1 Q. **Reference Avalon Capacity Study:**

Figure 1: ac Voltage Following Three-Phase Fault at the Bay d’Espoir Terminal Station

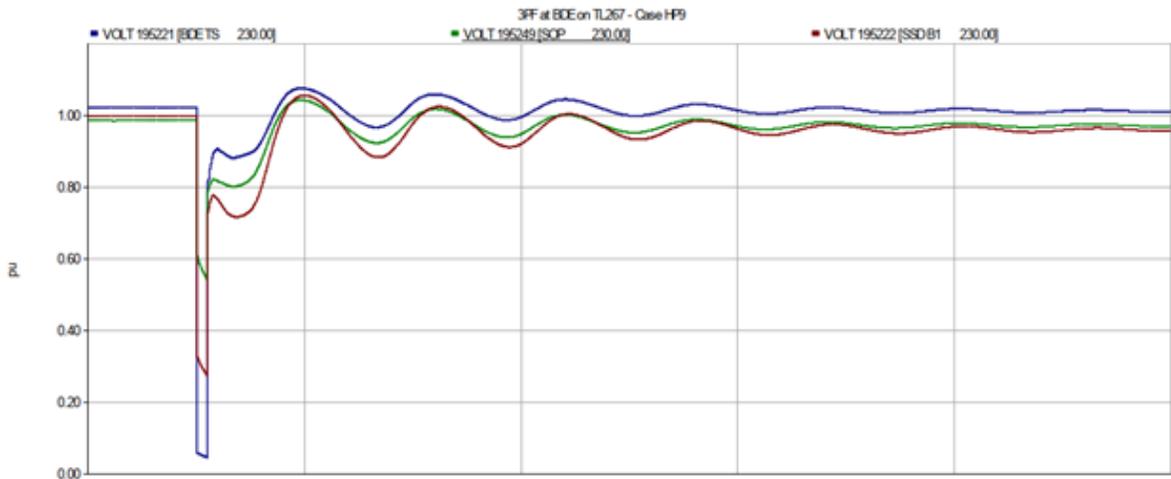
2 Reference Avalon Capacity Study: The measures required to meet the 3PF (Including BDE)
3 are much more extensive than those for the 3PF (not including BDE); please explain why
4 the ac network is so sensitive to this fault.

15 As per the results of the operational study, a three-phase fault at the Bay d’Espoir Terminal
16 Station results in suppression of reactive support during the fault and poor post-fault
17 recovery voltages in the area of the Sunnyside Terminal Station. This is illustrated in Figure
18 1 and is explained by the limited dynamic reactive support in the Sunnyside area as
19 compared to the reactive support provided by the generators in Bay d’Espoir and the
20 synchronous condensers in the Soldiers Pond Terminal Station.

22 The post-fault recovery voltages at the Sunnyside Terminal Station deteriorate as a function
23 of increased power flows in the transmission corridor between the Bay d’Espoir Terminal
24 Station and the Soldiers Pond Terminal Station. In the event of a Labrador-Island Link bipole
25 outage, power flows in the corridor increase significantly and voltages at the Sunnyside
26 Terminal Station may become suppressed to the point of collapse.
